ADDENDUM NUMBER 1

POWDER SPRINGS ROAD

SIDEWALK PHASE II

PROJECT NUMBER 13022

STATE OF GEORGIA
 DEPARTMENT OF TRANSPORTATION
 OFFICE:
MAINLINE PLAN
 POWDER SPRINGS ROAD
 SIDEWALK PHASE II
 DRAWING No.
13-04

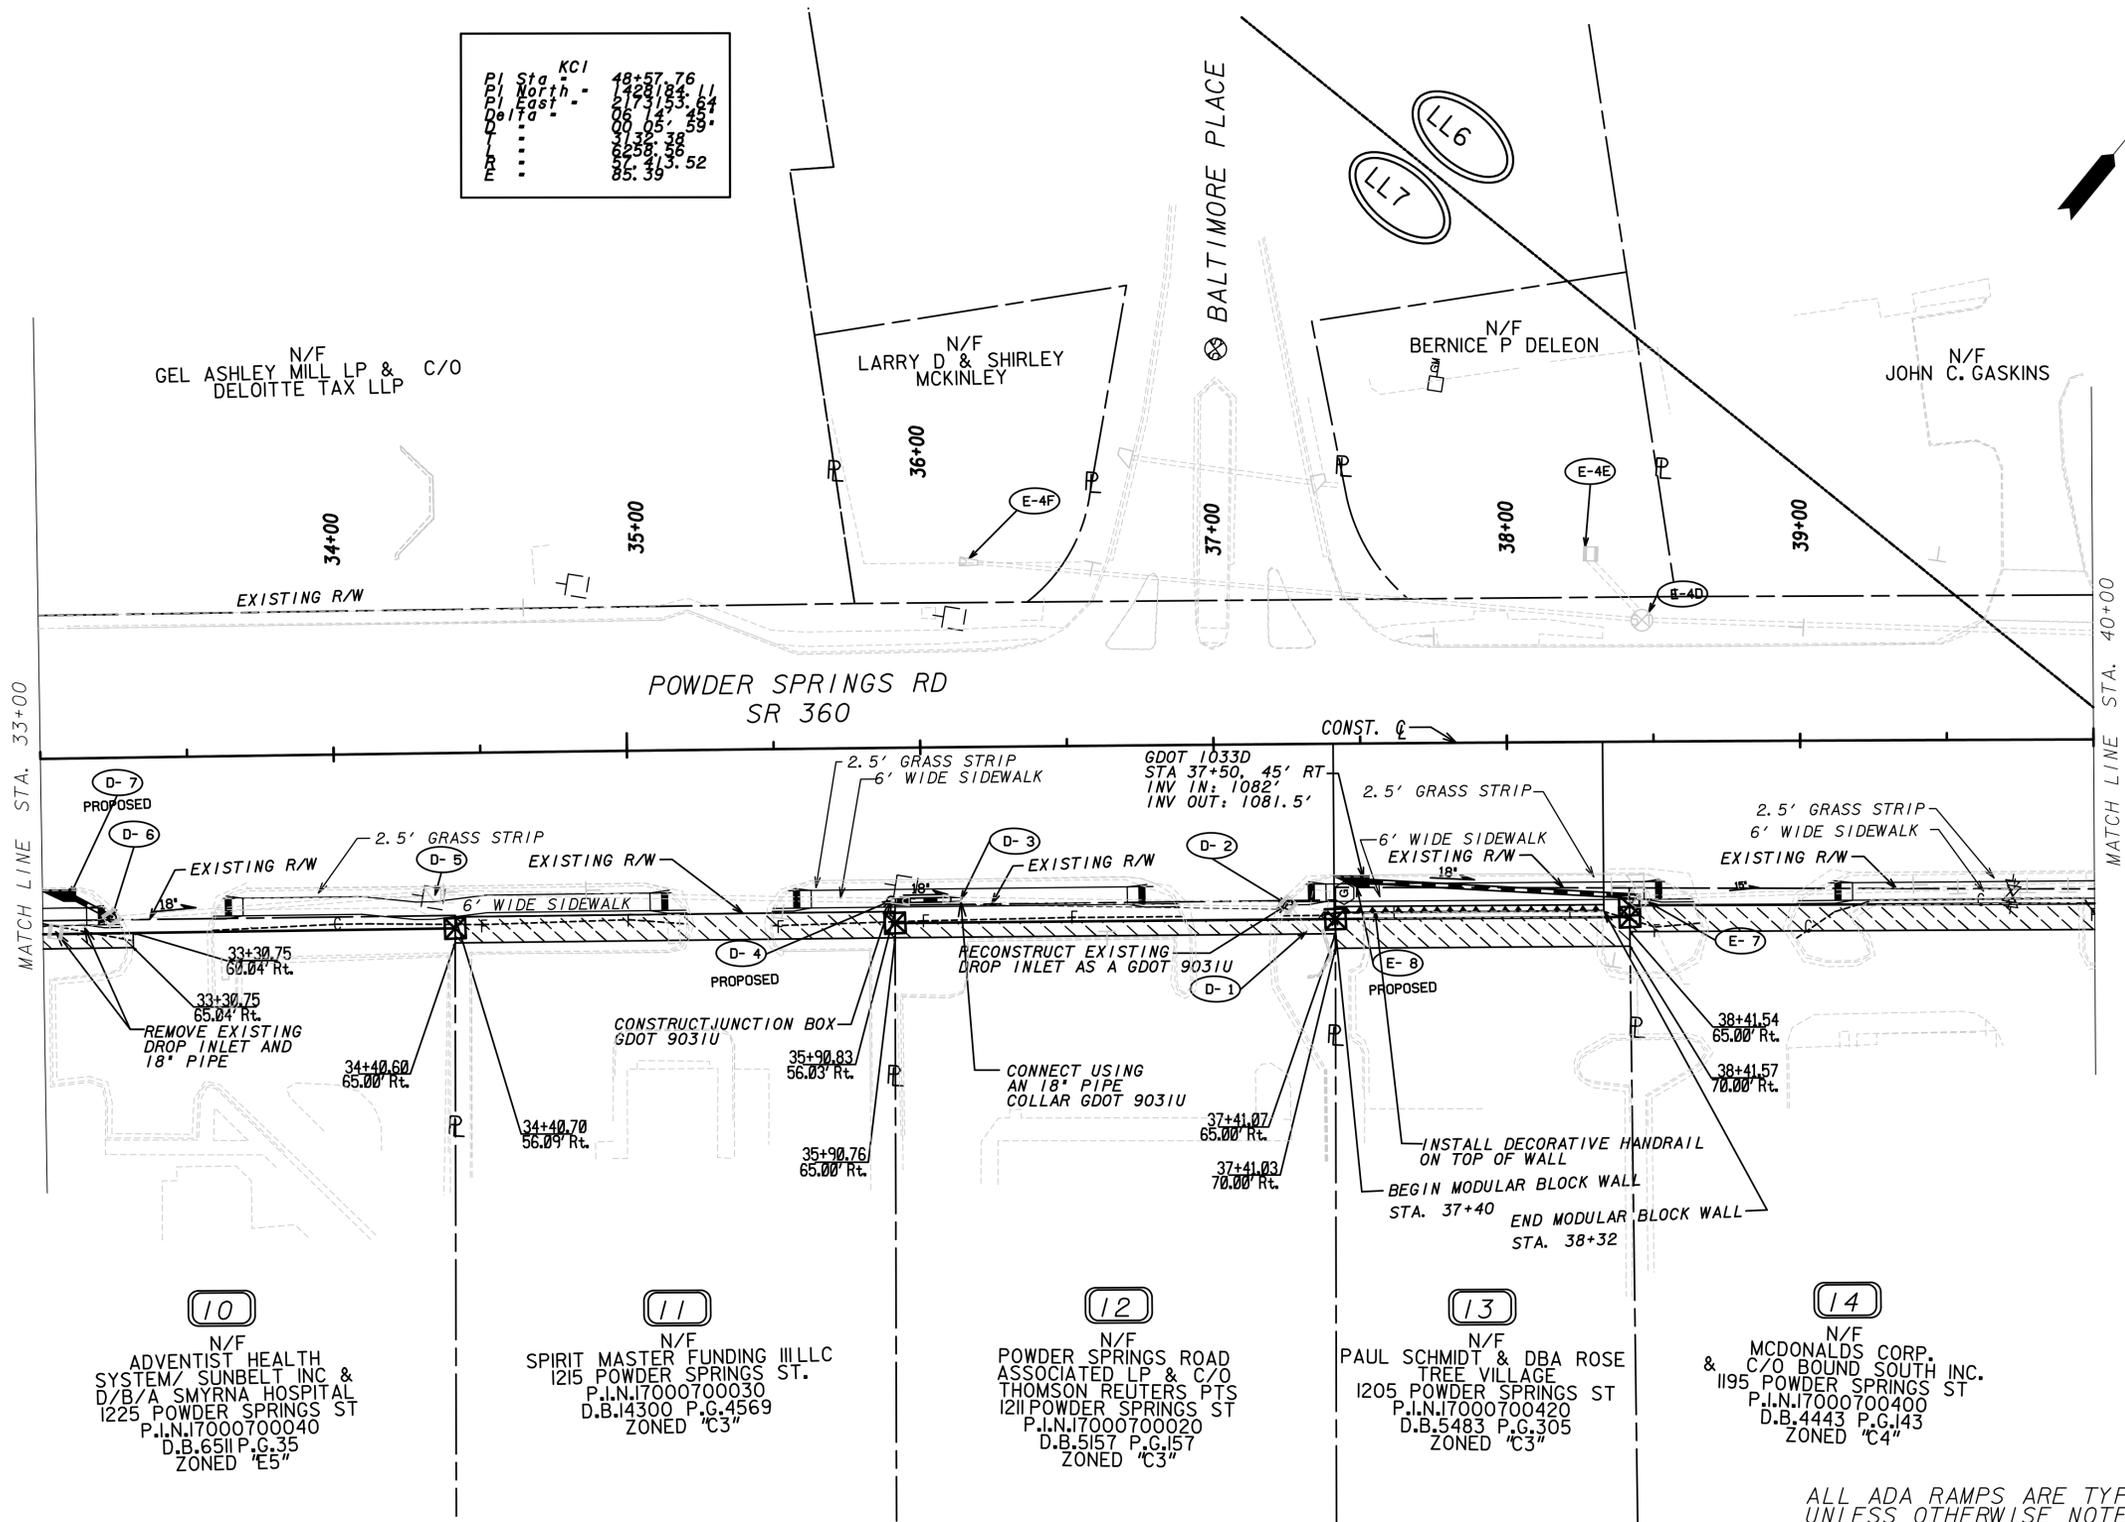
8. On sheet 13-04, how far down Powder Springs Rd. should we remove existing 18" pipe?

9. Is there any particular reason why on sheet 13-01 it states that drainage A-1, A-2, and A-3 are "proposed" whereas on other sheets (for example, E-8 on sheet 13-04) is not labeled "proposed" yet it is shown on sheet 22-01 as a GDOT 1033D?

15. On sheet 13-04, is the Decorative Handrail to be installed on an already existing wall or is this another new Modular block wall?

THE PIPE IS TO BE REMOVED, ALONG WITH THE DROP INLET, IN ITS ENTIRETY BETWEEN THE
TWO DROP INLETS.

THE "PROPOSED" LABEL WAS OVERLOOKED ON THIS STRUCTURE. IT HAS BEEN ADDED TO THE PLANS.

THIS WILL BE A NEW WALL. THE STATION CALLOUTS HAVE BEEN ADDED TO THE PLAN SHEET
